**Re: Data Request No. 5 for the Mesa 500-kV Substation Project (CPUC Proceeding A. 15-03-003)**

Attachment 1: Data Request #5

Attachment 2: Study of Mesa 500-kV Substation with One Transformer

Attachment 3: Study of No Project with Outages (N-1-1 outage of 500-kV transmission lines)

Case C  
Mesa 500-kV in service (1 transformer)  
Post N-1-1 outages

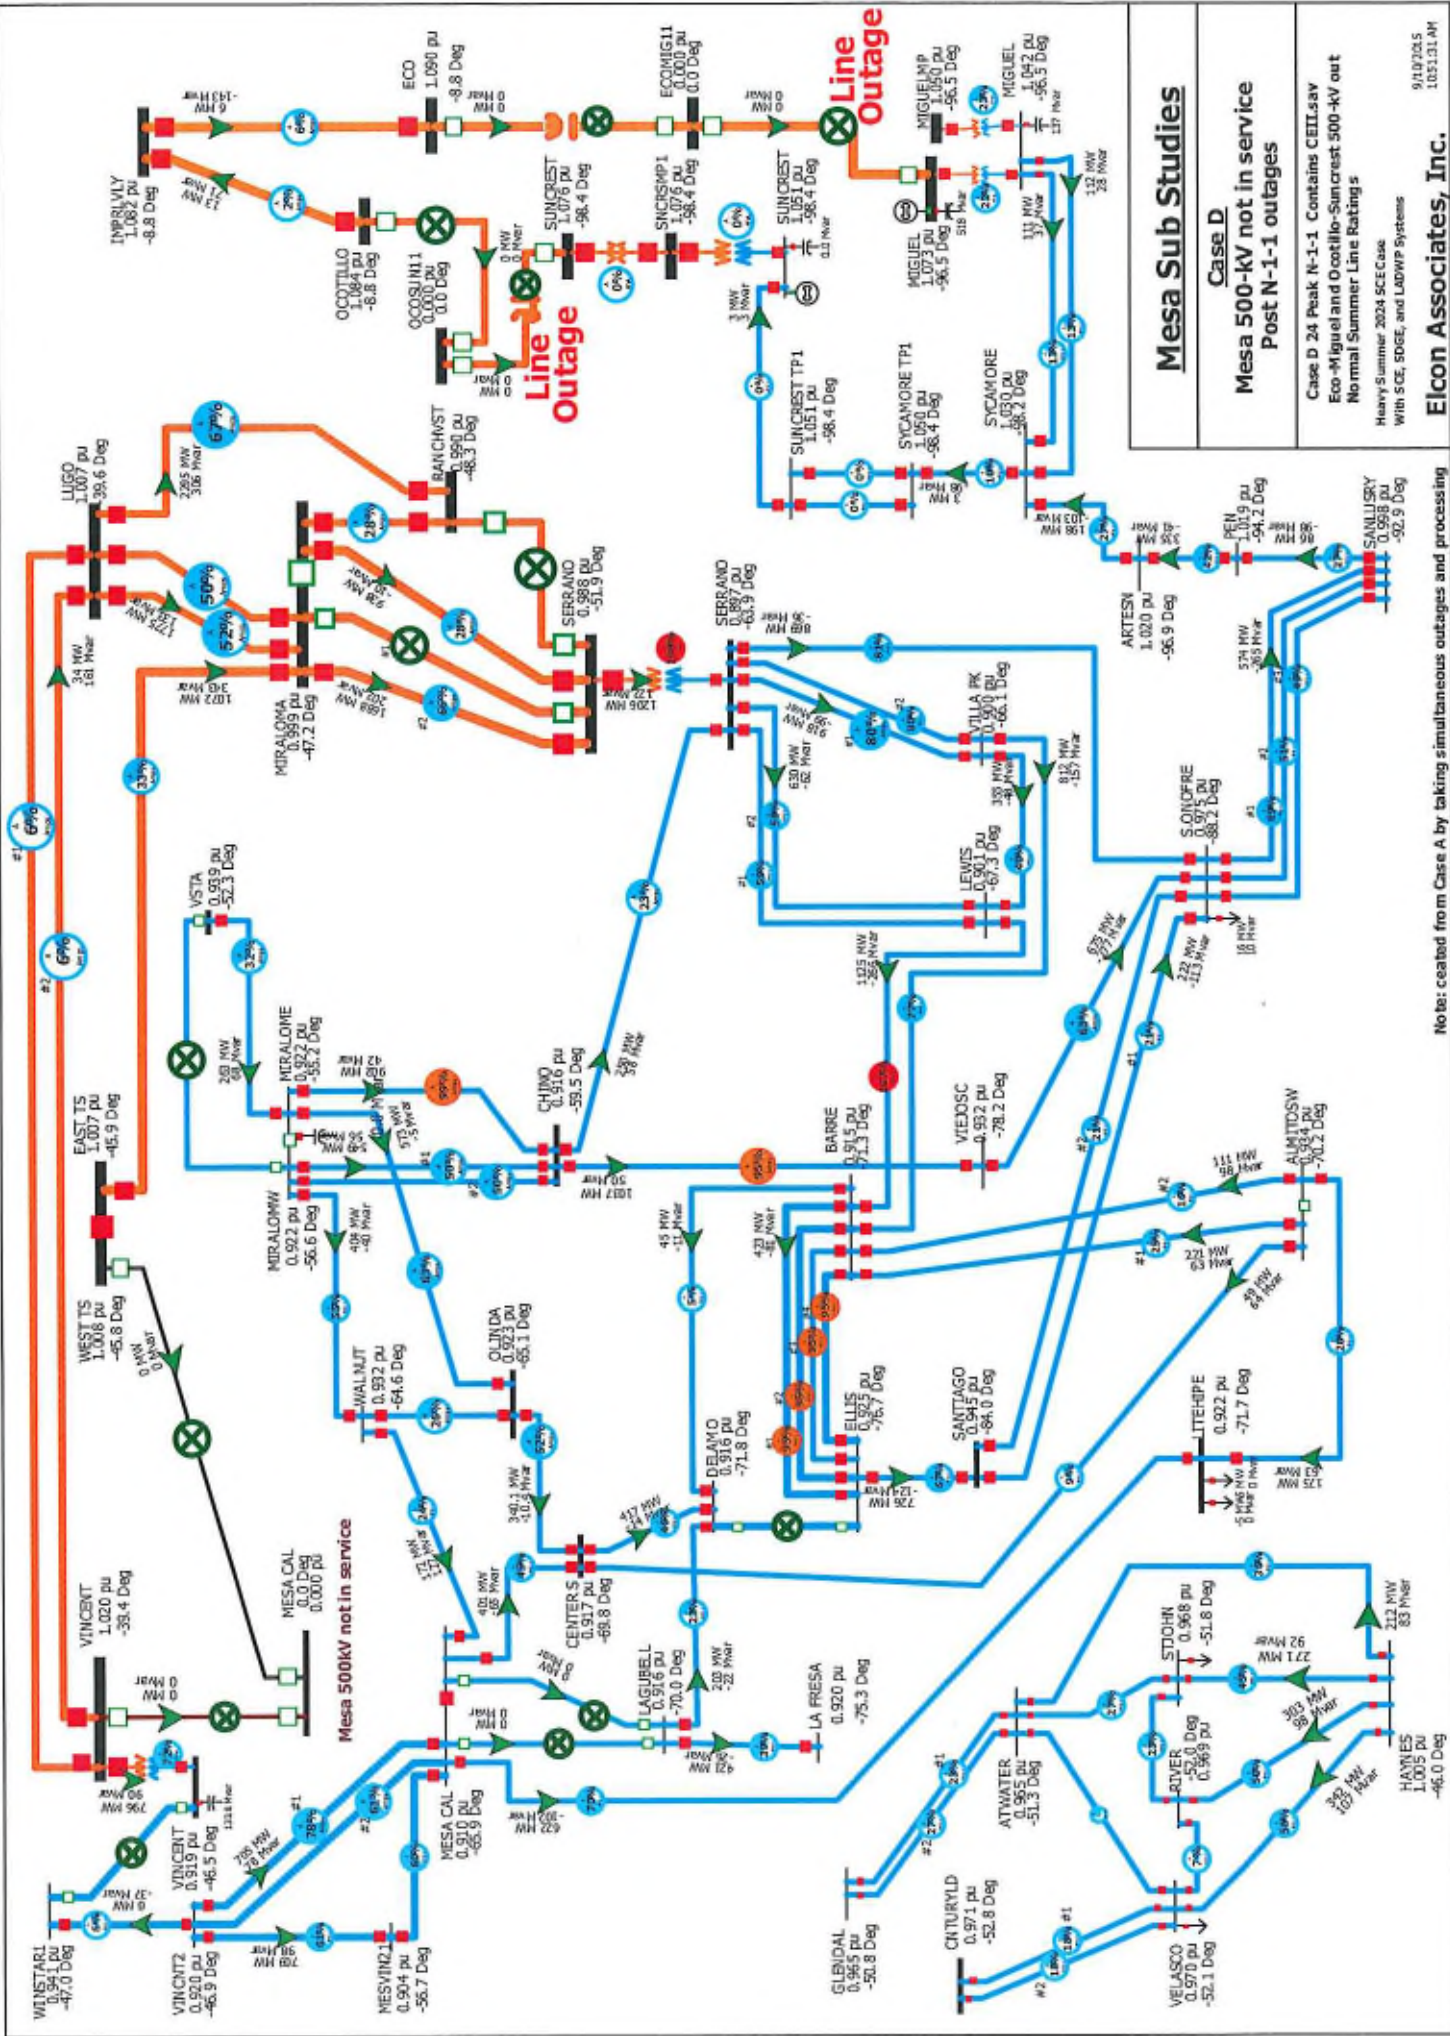
DR#5 Q.2	N/A	<b>Alternatives: Reduced substation alternative</b>	<p>A study, using SCE-provided data, demonstrates that one 500-kV transformer bank at a 500-kV Mesa Substation would address low voltage in the Serrano corridor following an outage of the Eco-Miguel 500-kV Transmission Line followed by an outage of the Ocotillo-Suncrest 500-kV Transmission Line (“500-kV N-1-1 contingency”). Refer to the study in Attachment 2. Provide the following information about a reduced substation alternative that would consist of one 500-kV transformer bank:</p> <ul style="list-style-type: none"> <li>A. State whether SCE concurs that one 500-kV transformer bank would address overloading on the Serrano Corridor following the 500-kV N-1-1 contingency. If not, explain why not.</li> <li>B. Would it be feasible to construct a 500-kV substation with one transformer bank west of the existing 230-kV substation? Explain why or</li> </ul>
